File Number	PLVAR-2504-0007	Contact	Natalie Lavenstein, nlavenstein@duluthmn.gov	
Type	Variance from Shoreland Area Standards	Planning Commission Date		June 10, 2025
Deadline for Action	Application Date	May 19, 2025	60 Days	July 18, 2025
	Date Extension Letter Mailed	May 19, 2025	120 Days	September 16, 2025
Location of Subject		9426 Congdon Blvd		
Applicant	Amanda Flowers	Contact	NA	
Agent	NA	Contact	NA	
Legal Description		010-0300-00560		
Site Visit Date		May 28, 2025	Sign Notice Date	May 23, 2025
Neighbor Letter Date		May 19, 2025	Number of Letters Sent	12

Proposal

The applicant is requesting a variance to build a deck in the rear yard within the structure setback of Lake Superior. The deck would be 32.3' from the Ordinary High Water Level of Lake Superior instead of the required 50 ft.

Variance
9426 Congdon Blvd

CERTIFICATE OF SURVEY
FOR: AMANDA FLOWERS

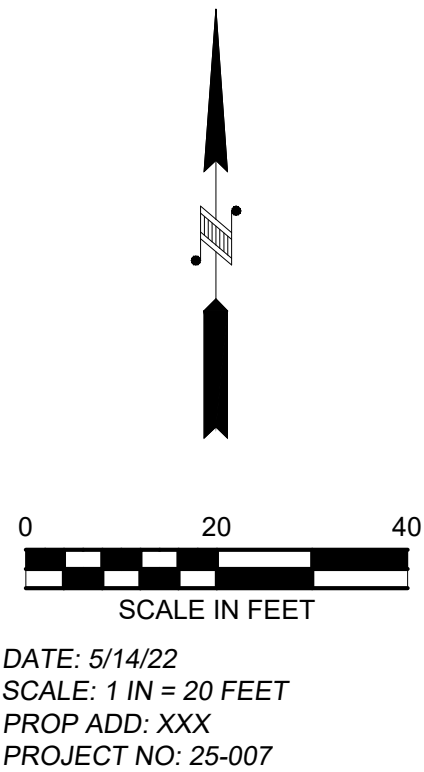
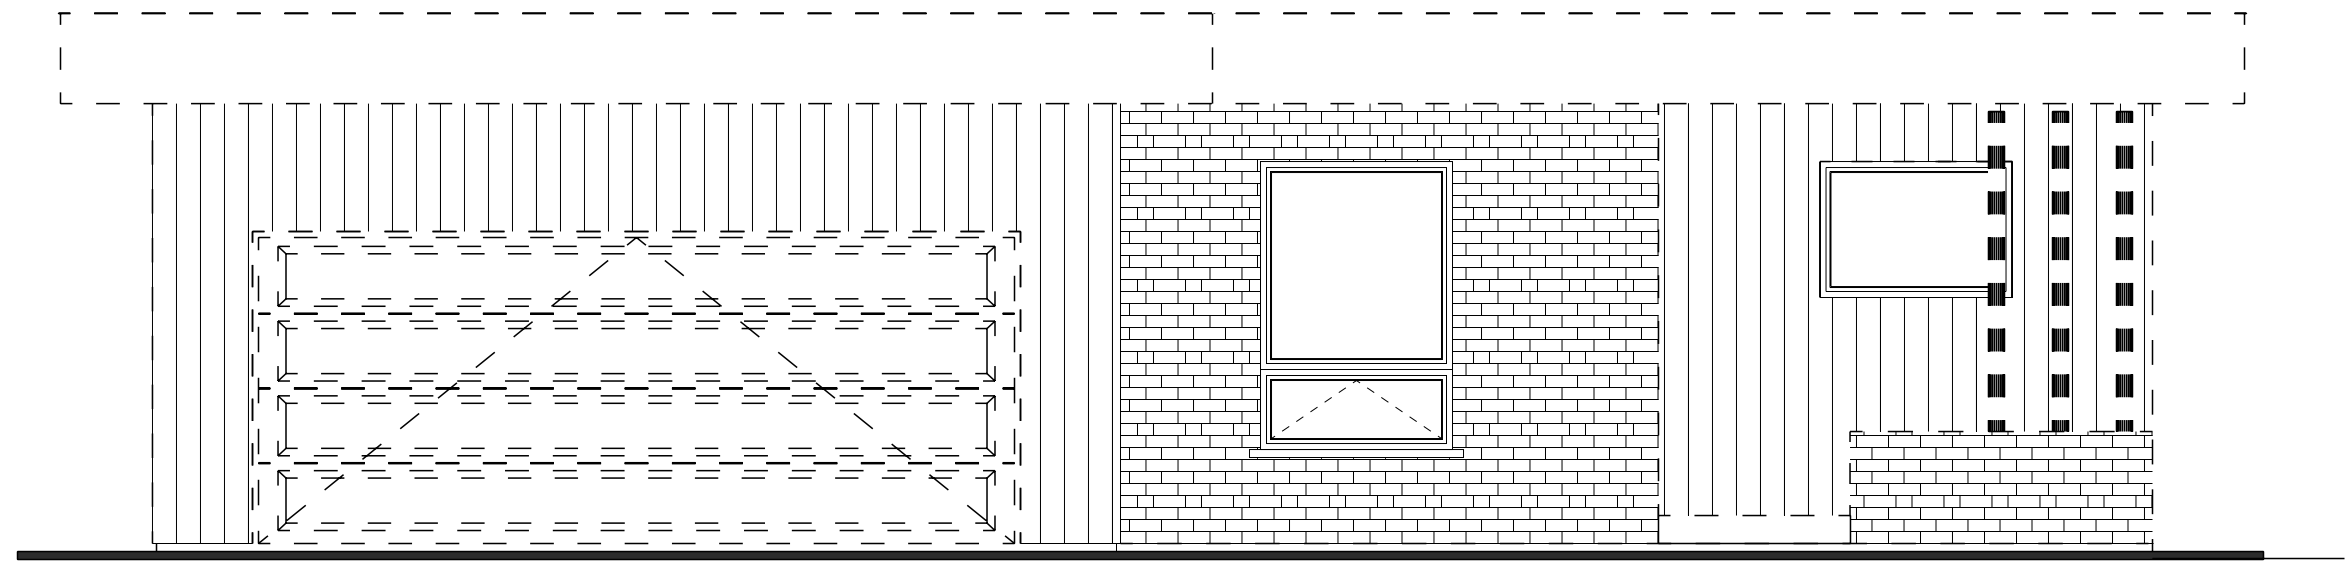
- 1) The applicant proposes to construct a 10' by 15' deck on the upper level of the home. The entire rear yard is within the structure setback of Lake Superior. The deck would be 32.3' from the Ordinary High Water Level of Lake Superior instead of the required 50 ft.

- 8) One public comment was received in support of the proposed variance. No agency or City comments were received.
- 9) *Standards for variances in shorelands (does not compromise intent of shoreland regulations and mitigates impacts):* The deck does not add significant impervious surface and will have minimal impacts to water quality. As mitigation, the applicant proposes native plantings and no mowing as shown in the attached exhibit. This brings the property further into compliance with the goals of the shoreland ordinance, which aims to preserve naturally vegetative areas adjacent to shorelands.

1. Applicant shall implement the mitigation plan, including establishment of naturally vegetative areas, and will put no additional impervious surfaces within the rear yard.
2. The project be constructed and maintained according to the site plan submitted with this application.
3. Any alterations to the approved plans that do not alter major elements of the plan may be approved by the Land Use Supervisor without further Planning Commission action; however, no such administration approval shall constitute a variance from the provisions of Chapter 50.
